CITY OF ISSAQUAH
DEVELOPMENT SERVICES
DEPARTMENT DEVELOPMENT
COMMISSION

STAFF REPORT

FILE NO.: Community Conference: COM15-00001

PROJECT: Fieldstone Memory Care

SITE PARKING

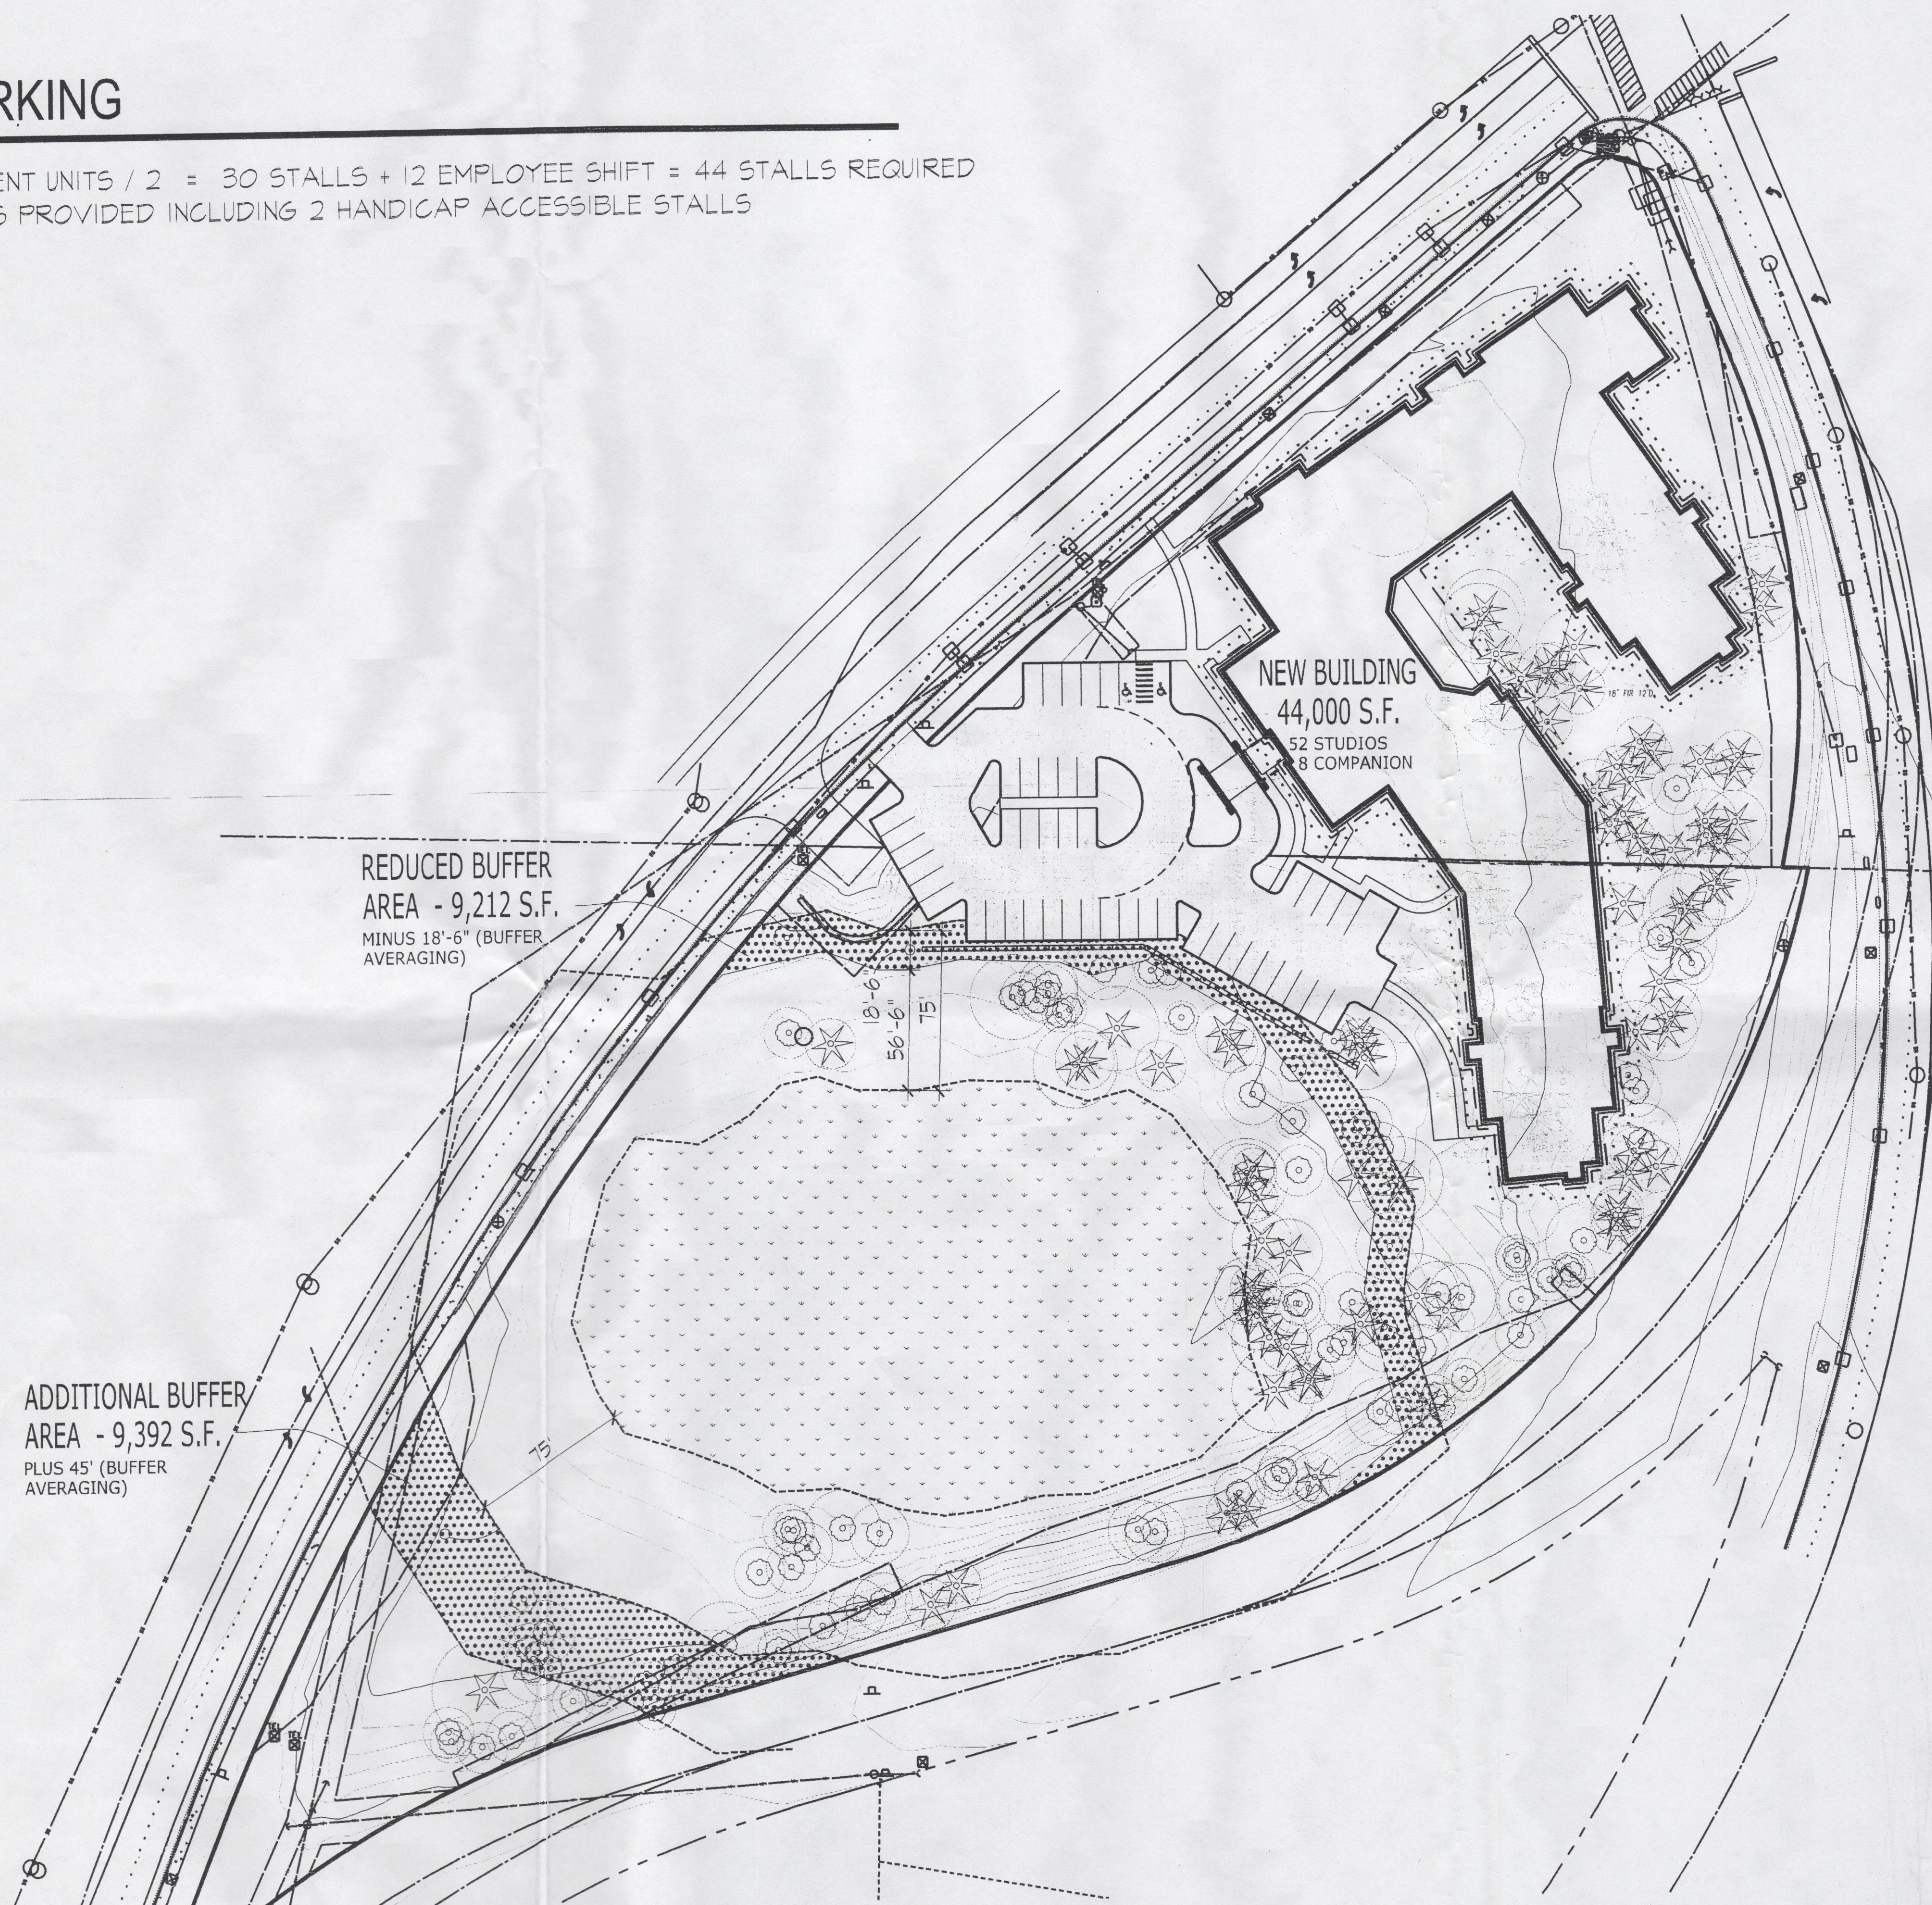
Fire access: Access to the building is provided from a driveway off of Issaquah-Fall City Rd that connects to the parking lot. A computer model for fire apparatus in the parking lot will be required to ensure it meets vehicle turning radii requirements. The turn radii in the parking lot will be required to meet the fire code standard. A perimeter walkway around the building will be required. The hammerhead in the very front of the building will need to meet fire code standards.

Off-Street Parking: The Table of Off-Street Parking Standards, IMC 18.09.050, require one stall for every two beds plus one stall per employee at the maximum shift. The facility proposes to have 60 beds and 15 staff member on site at the max shift; therefore, a minimum of 44 parking spaces is required for the new facility.

Standard stalls are 9' x 20' with a 24' backup maneuvering aisle. The applicant is proposing 44 parking stalls total.

The circulation for the parking appears to meet the code requirements, though fire requirements may later the design of the parking lot in order to meet emergency vehicle turning radii. Additionally, more parking stalls may be required than shown in order to meet the codes provisions for minimum parking.
